# UNITED STATES PATENT AND TRADEMARK OFFICE

APPLICATION NO.	FILING DATE	FIRST NAMED INVENTOR	ATTORNEY DOCKET NO.	CONFIRMATION NO.
10/626,966	07/25/2003	William G. Dennis	MPD-001.01	3962
25181	7590	02/20/2008	EXAMINER	
FOLEY HOAG, LLP PATENT GROUP, WORLD TRADE CENTER WEST 155 SEAPORT BLVD BOSTON, MA 02110			NGUYEN, TUAN VAN	
ART UNIT	PAPER NUMBER			
	3731			
MAIL DATE	DELIVERY MODE			
02/20/2008	PAPER

<b>Office Action Summary</b>	<b>Application No.</b> 10/626,966	<b>Applicant(s)</b> DENNIS, WILLIAM G.
	<b>Examiner</b> TUAN V. NGUYEN	<b>Art Unit</b> 3731

**DETAILED ACTION**

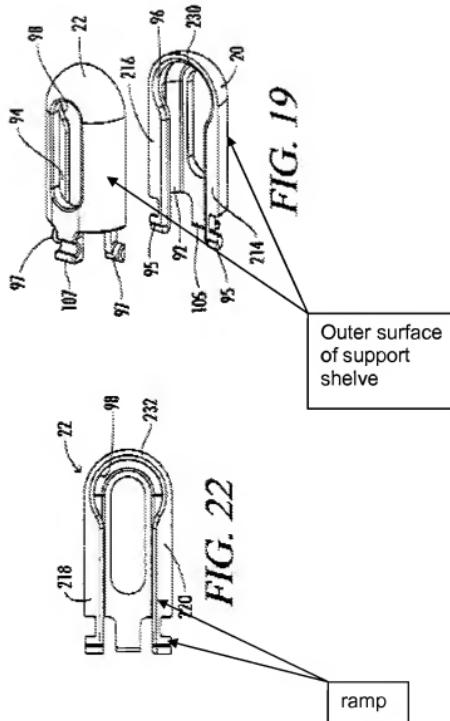
4. Applicant's argument filed on November 13, 2007 with respect to that Figs. 19 and 21 of Shipp's drawings show the elements 95 and 97 are not continuous with the outer surfaces of the respective support shelves has been fully considered but they are not persuasive. Figures 19 and 22 of Shipp's drawings clearly show a pair of ramp, which includes elements 95 connected with first jaw side 214 and 216 (see Fig. 19), and elements 97 connected with second jaw side 218 and 220 (see Fig. 20), wherein the ramps having outer surfaces that aligned with the respective

support rails 61 and 63 of the clip holder 58 (see Fig. 16) and are continuous with the outer surfaces of the respective support shelves (see Figs. 19 and 22 copied below this paragraph).
